New Port Facility Falkland Islands

Supporting statement to variation of condition application

Revision	Date	Description	Prep	Check	App
P02	24-Aug-2022	Final for planning submission	MS	RP	MS

Contract No:	Doc No:	Status	Revision
BAM	BAS.2051	BAS2051-RHD-ZZ-ZZ-FN-YE-5037	S4	P02
RHDHV	PB7829	PB7829-RHD-ZZ-ZZ-FN-YE-5037	S4	P02

Title Stage Two
Proposed Compound Areas:
Area 9 - silt management

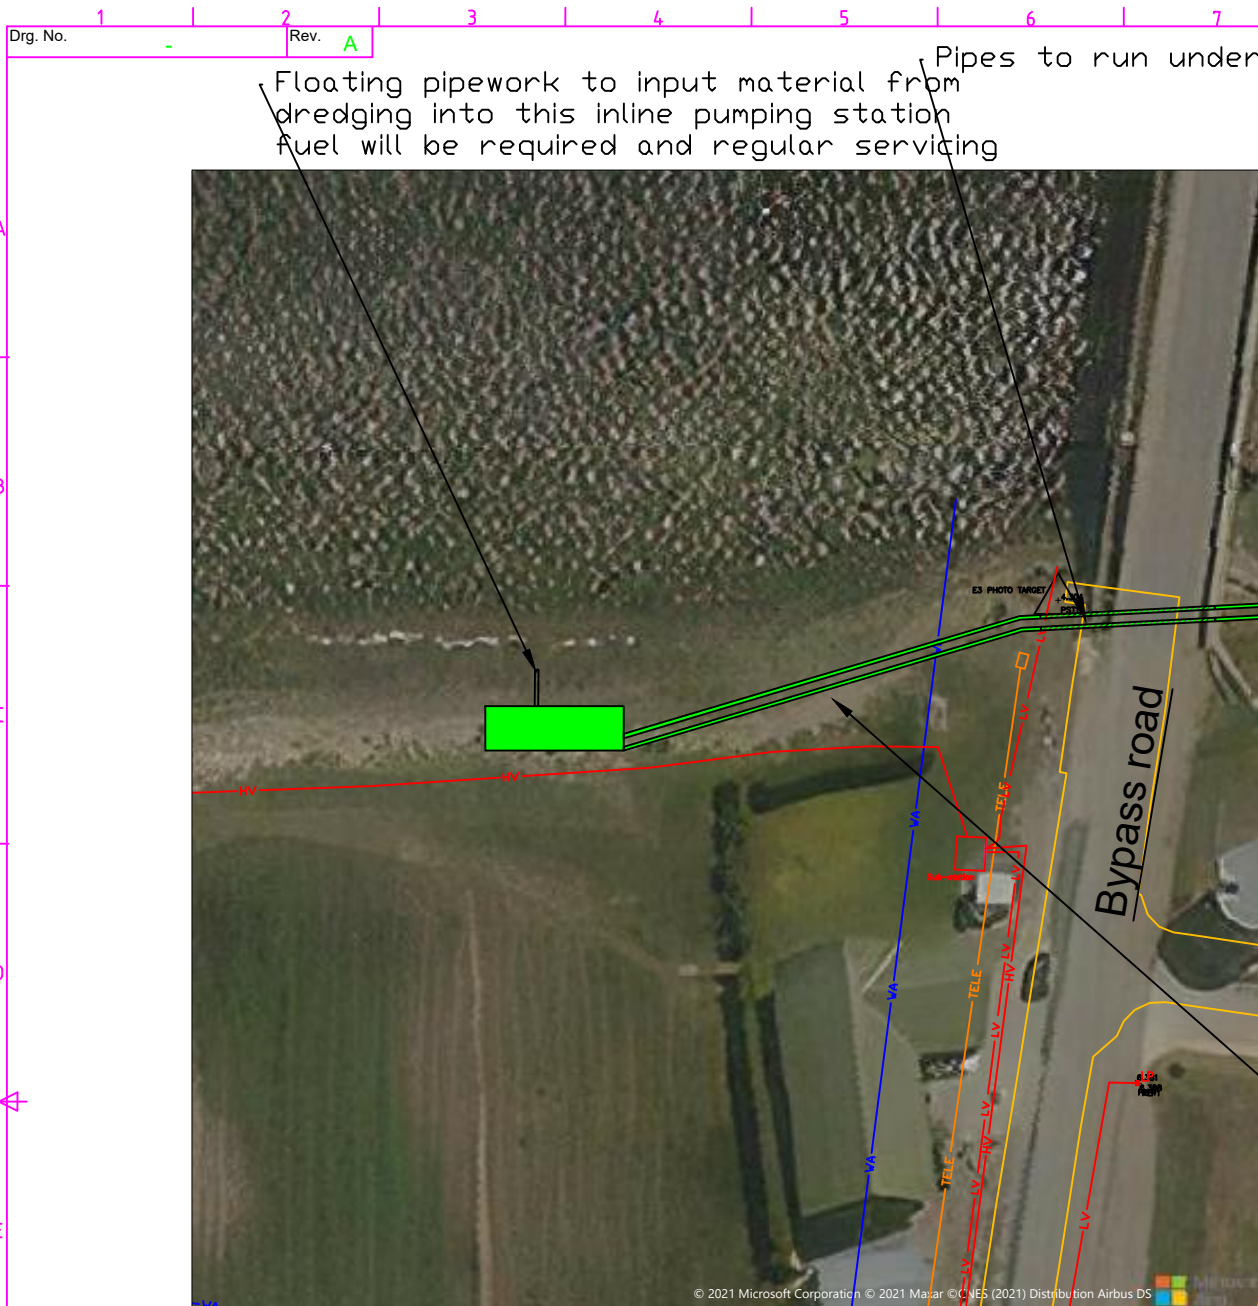
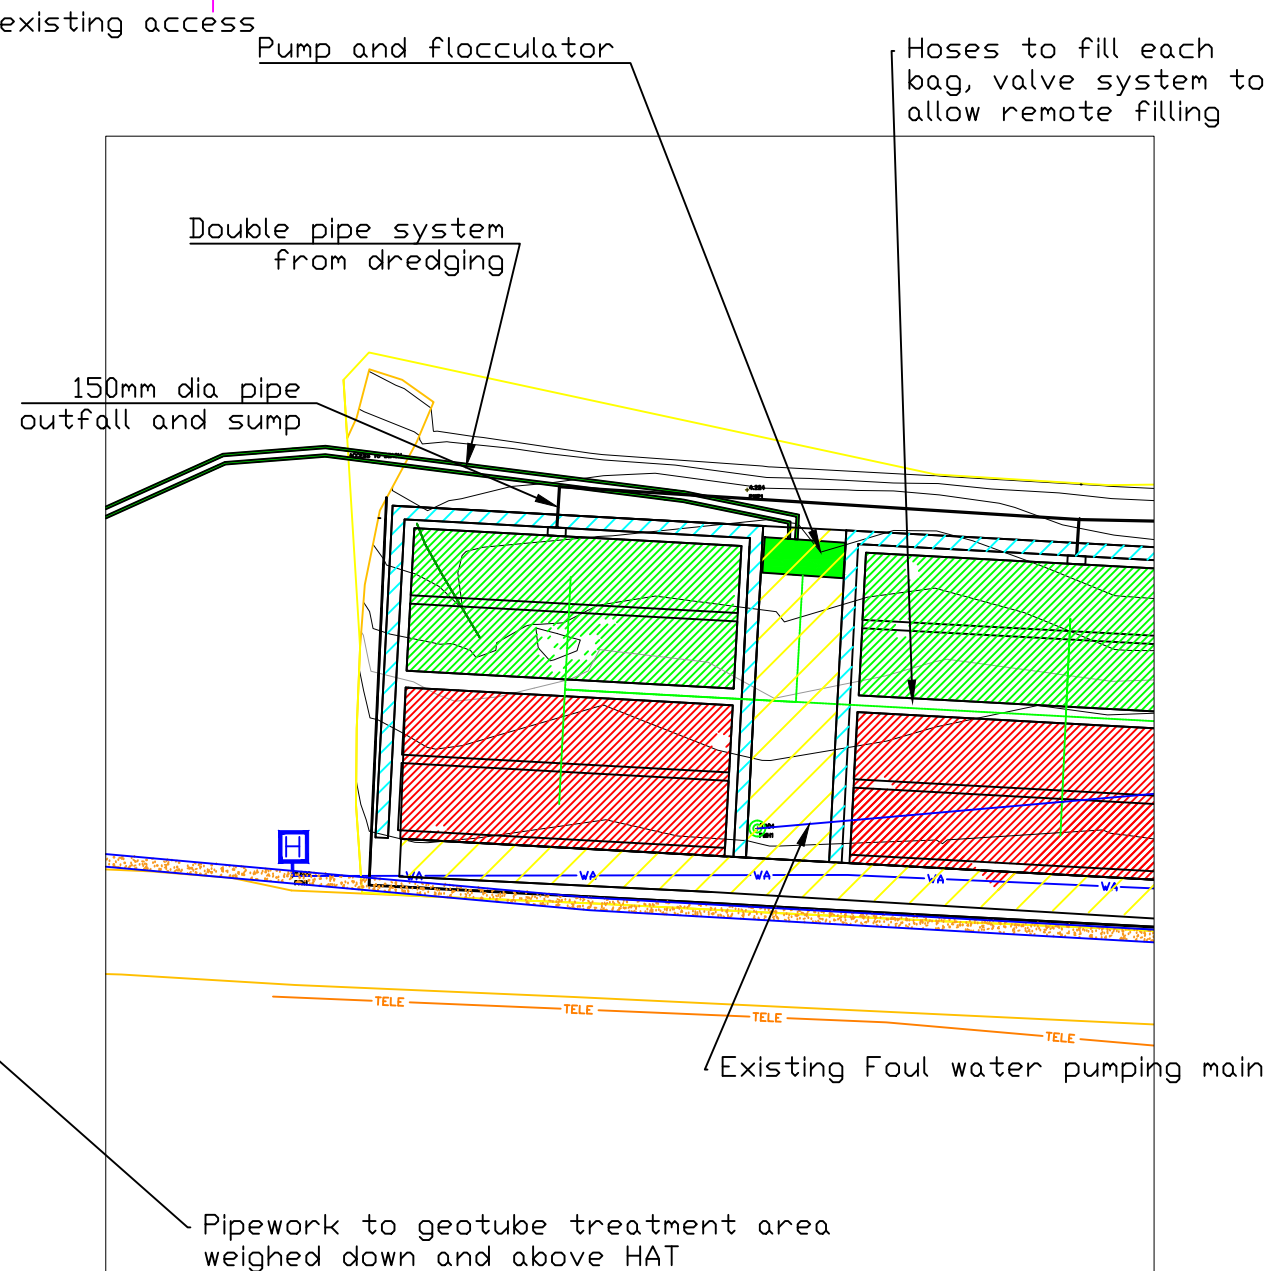
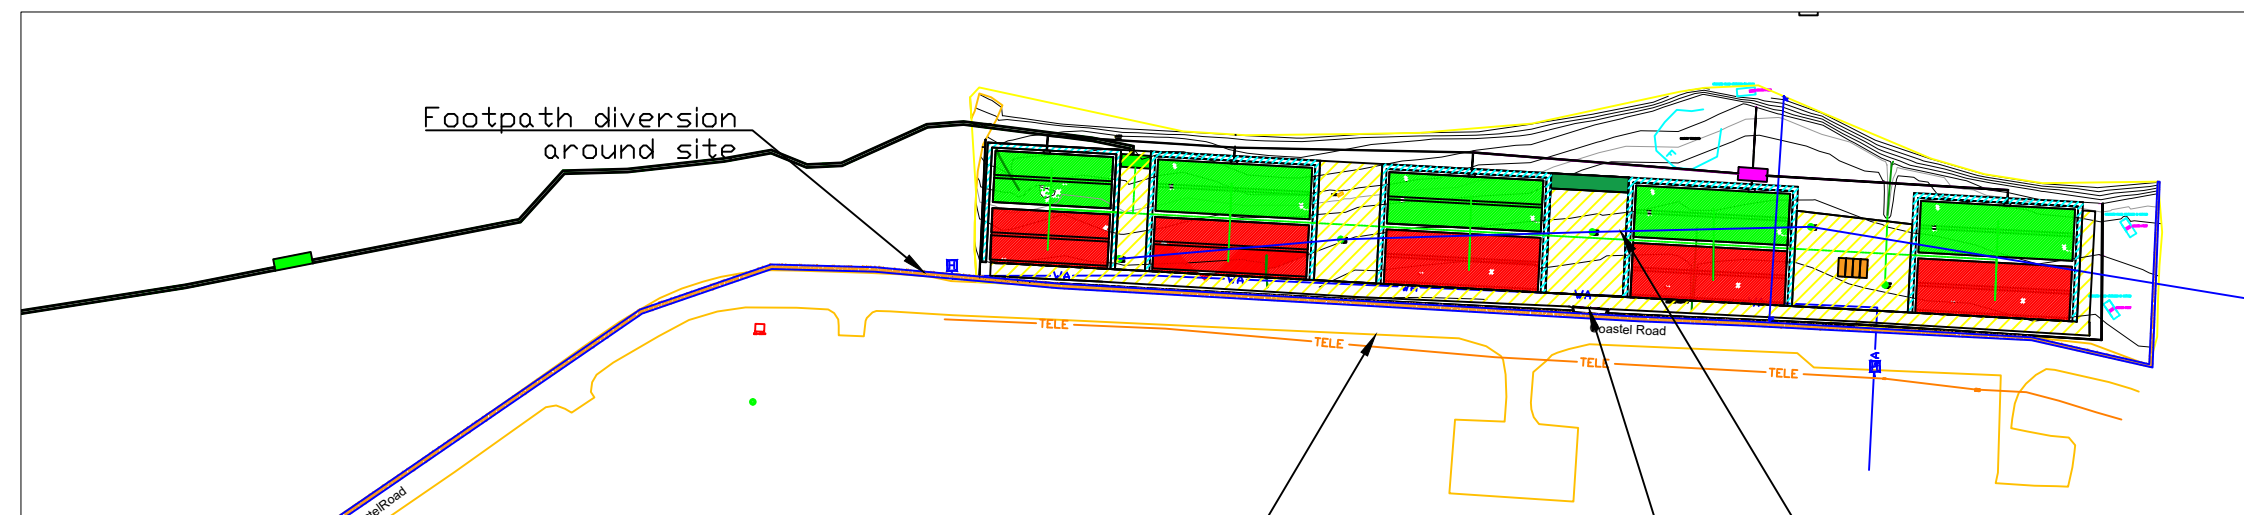
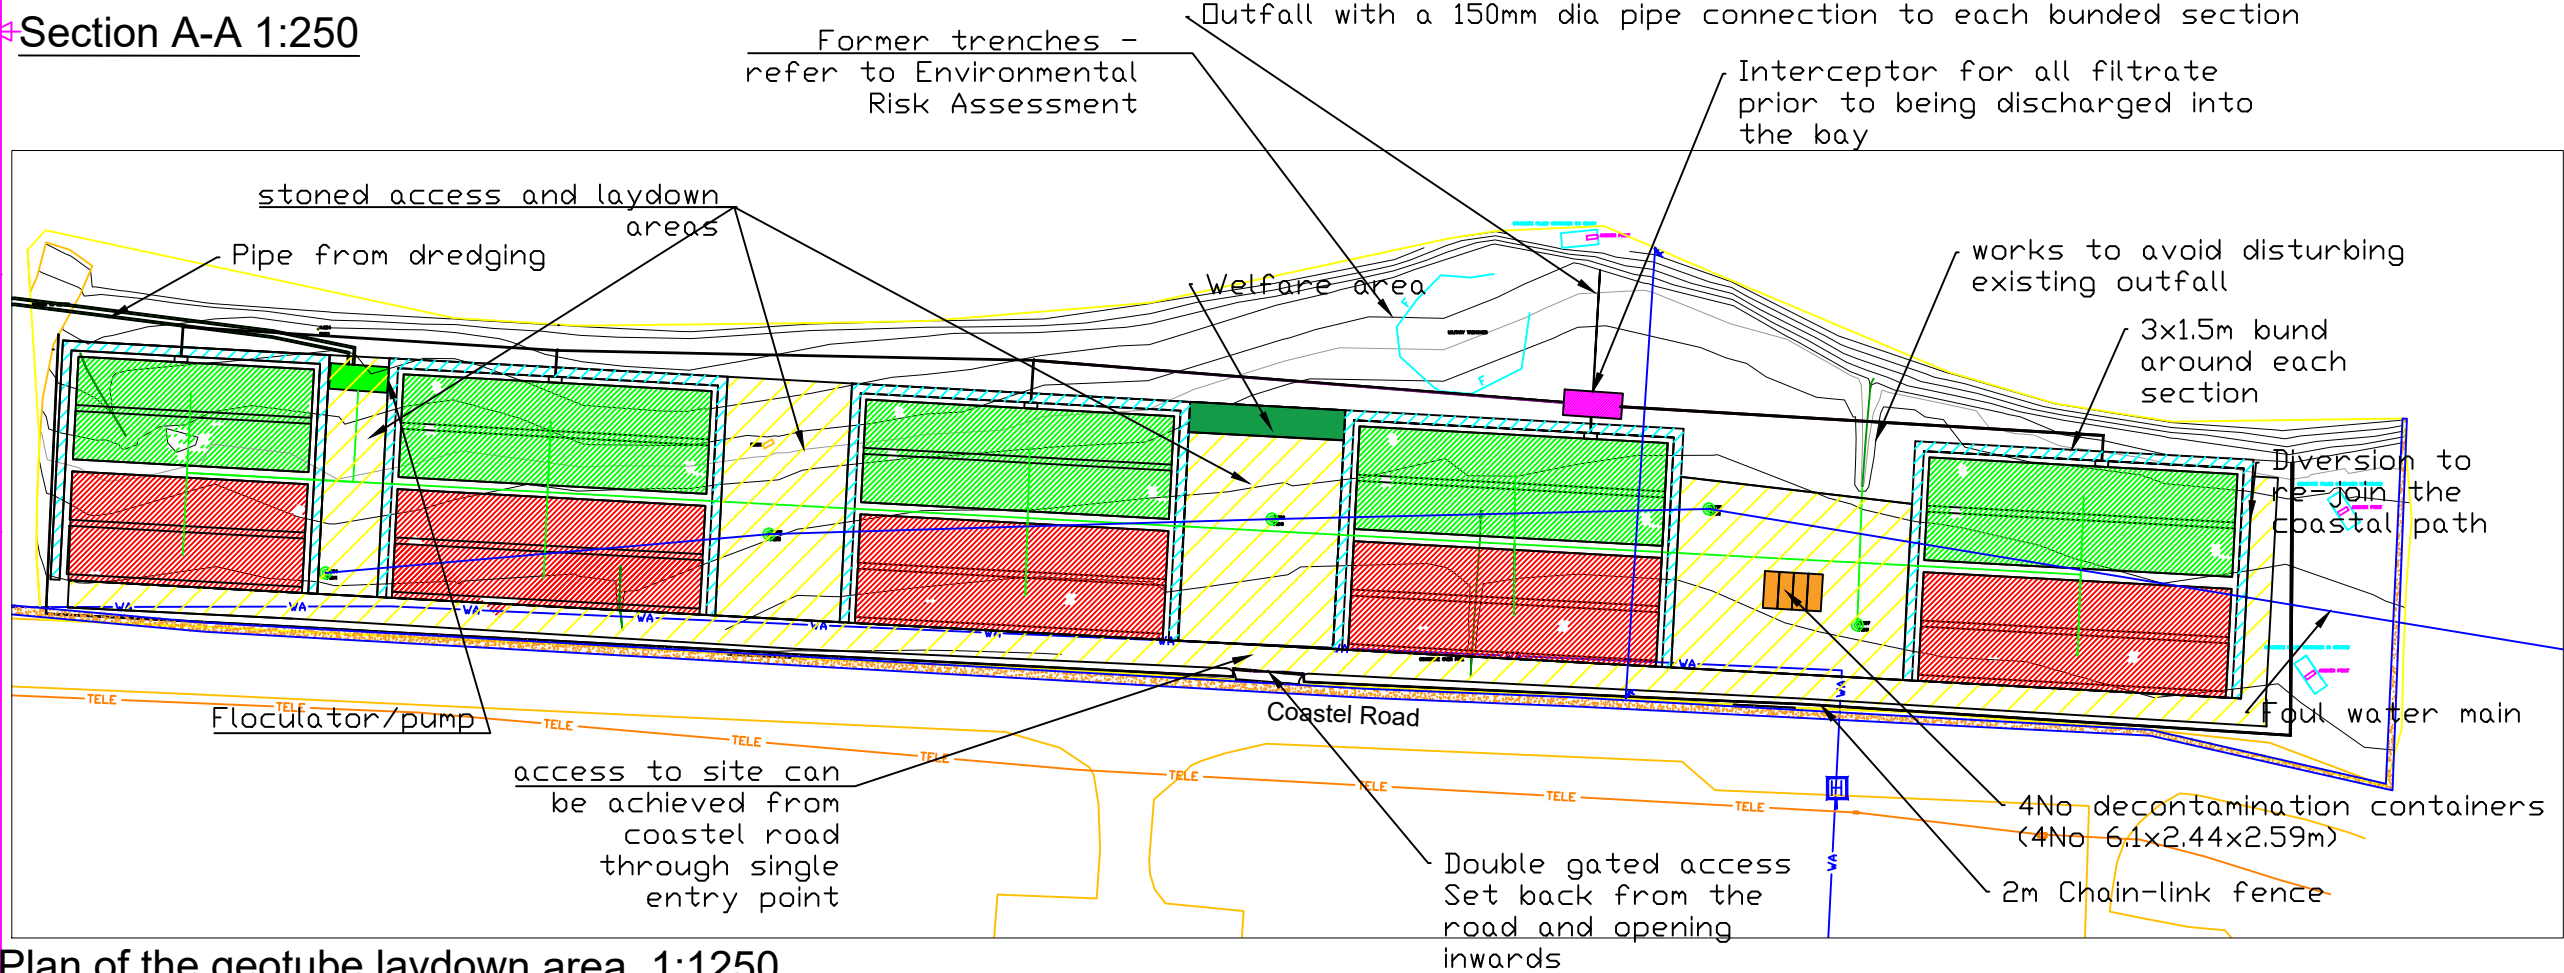
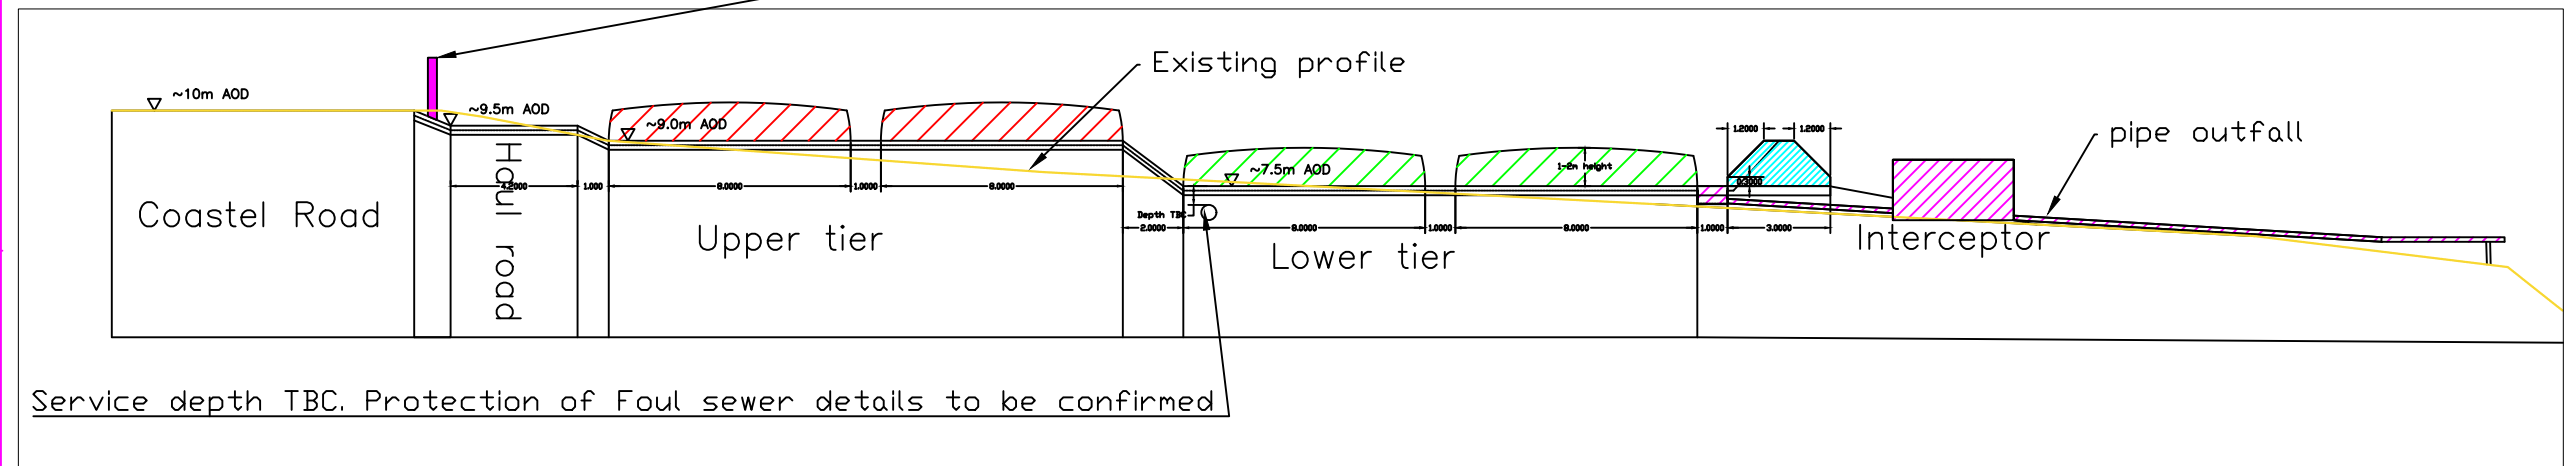
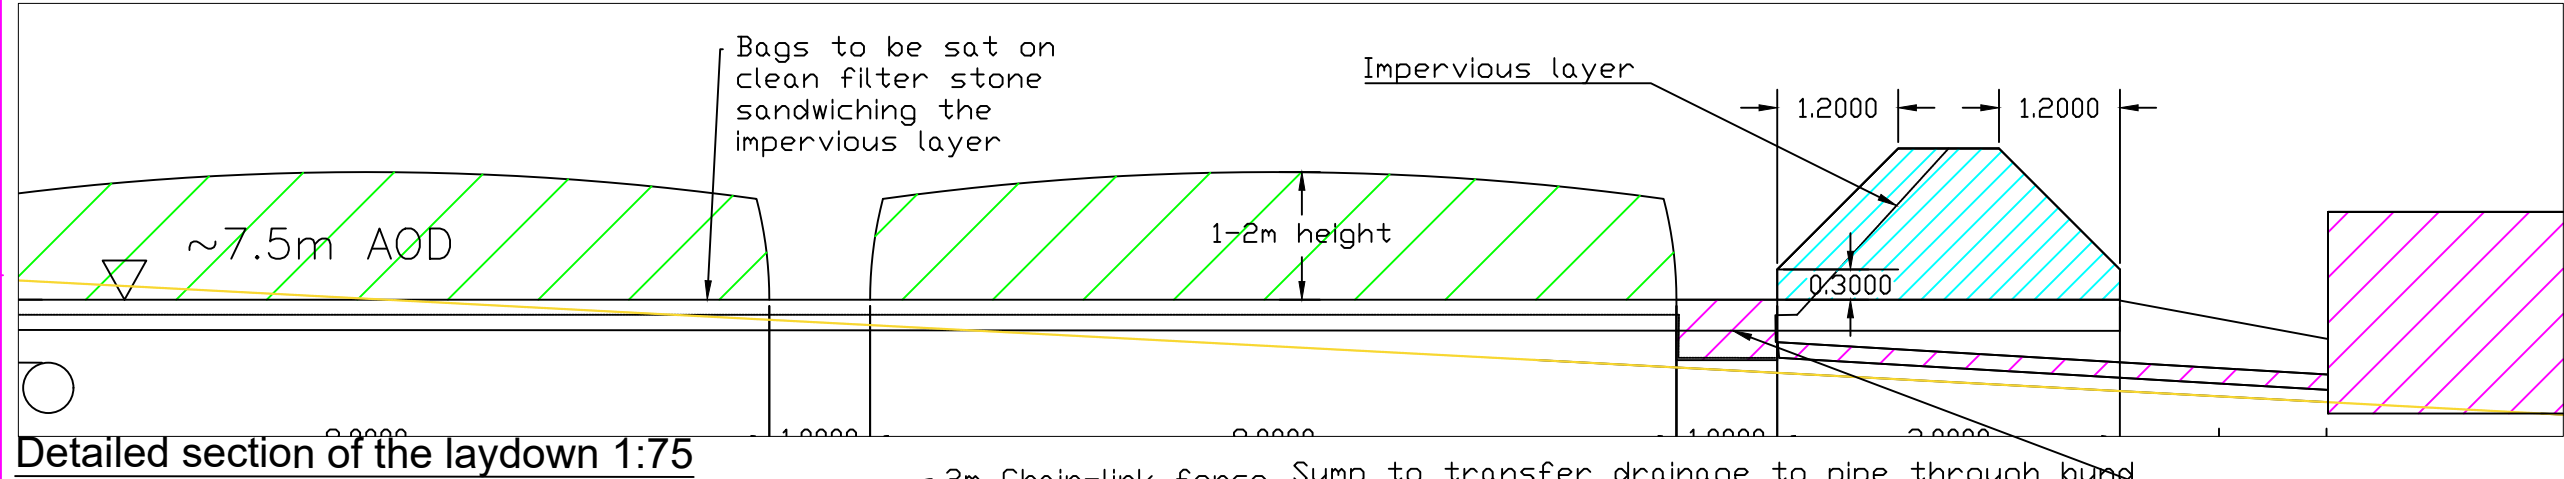
Variation to	Details	Primary condition or content affected
Amended use of remediation area	Additional controls are proposed for Cell 1, which is now proposed to receive hazardous materials from ballast tanks instead of a containerised system originally proposed. Material in Cell 1 will be disposed in landfill in the Falkland Islands.	Condition 4 - Construction Works – Construction Environmental Management Plan
Drawings	Approved Plans updated, some of which are included as supporting drawings to the EIS.	Condition 2 – Approved Plans
